Lloyd's Register of British & Foreign Shipping.

Belfast, 24th April 1906.

Messrs Workman Clark & Co
state that the Owners of their SS 234
wish them to supply that vessel with
the following outfit, viz.

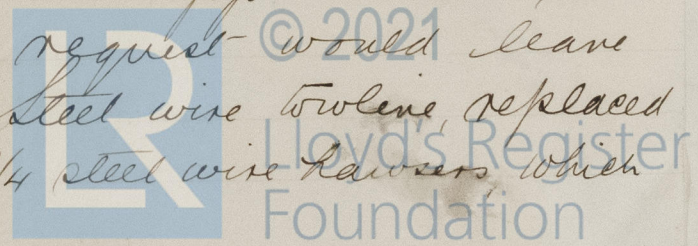
120 fms	5"	Steel wire	120 fms 5"
4 in ho. 100 fms	2 3/4"	" "	TL. 130 fms 5 1/2"
2 in ho 100	"	8" Manilla hawser.	2-100-8
2 in ho 100	"	6" "	" 2-100-8

in lieu of Reel equipment viz

120 fms	5"	Steel wire
130 fms	5 1/2"	" "
4 in ho 100 fms	8"	Manilla hawsers.

As the above request would leave
the 130 fms 5 1/2" Steel wire towline replaced
by 2 of 100 fms 2 3/4" steel wire hawsers which

is not equivalent thereto, I beg to submit the proposal to the consideration of the Committee.
